Round One, Set Five  
Materials Engineering Branch  
121.10

120.0 MATERIALS ENGINEERING BRANCH

121.0 Materials Integrity Section

FIGURE 1  
FIRST CYCLE VOID COEFFICIENT  
FOR STABILITY ANALYSIS

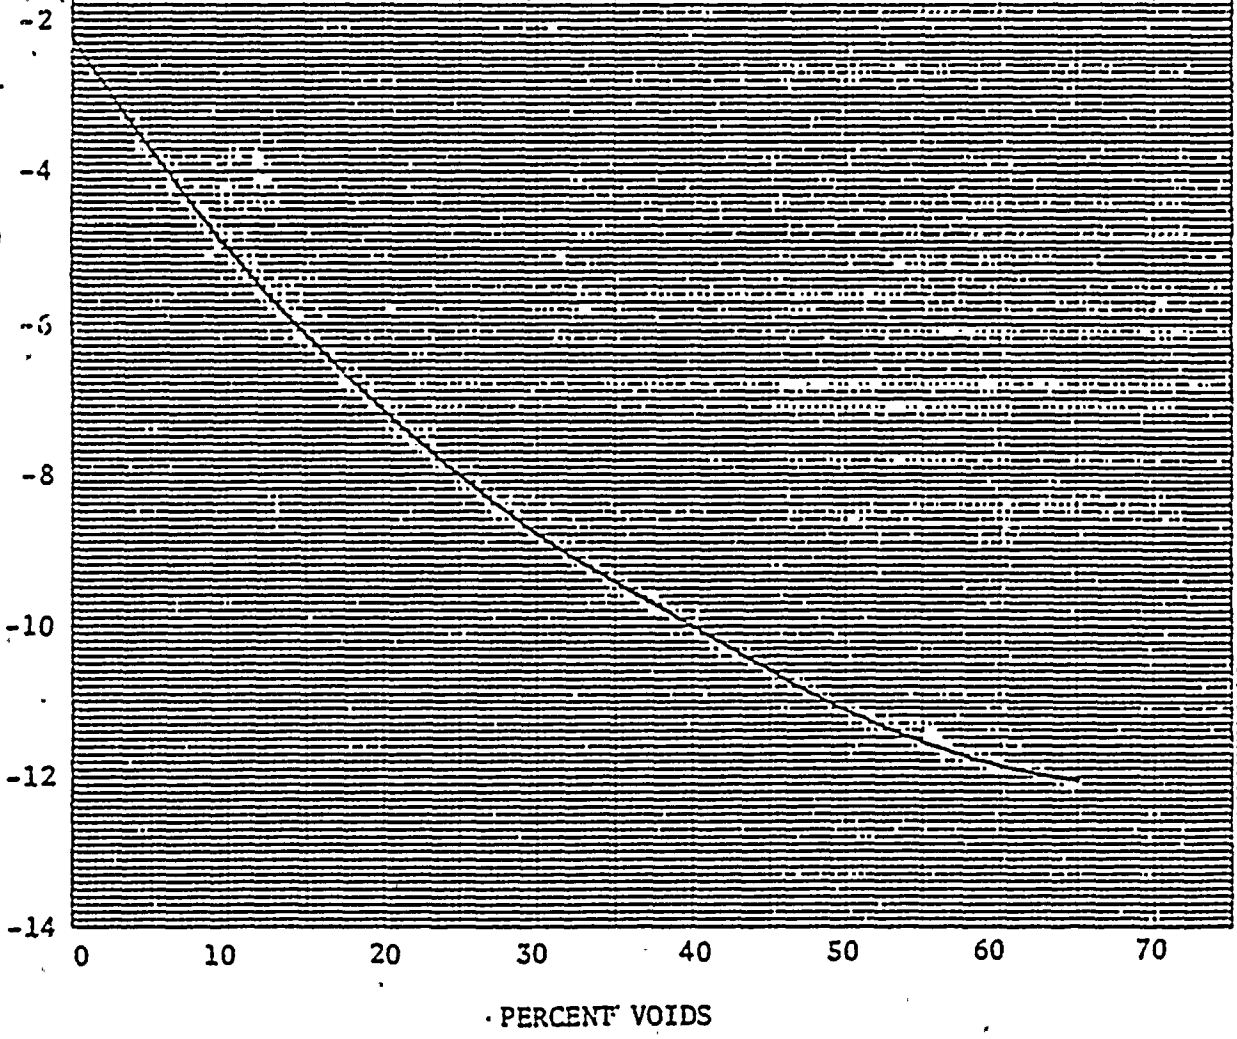
In Section 4.4.4.6.7 of the FSAR, you state that the most limiting condition for thermal-hydraulic stability occurs at the end of core life with power peaking toward the bottom of the core. Indicate whether the typical values of core stability provided in this section are based on the core characteristics at the end of core life. If not, provide values of the decay ratio for this condition. Provide the power profile and the void reactivity coefficients used for this analysis.

The core stability results provided are based on core characteristics near end of cycle 1\* condition, which is the most limiting for cycle 1\* plant operation.
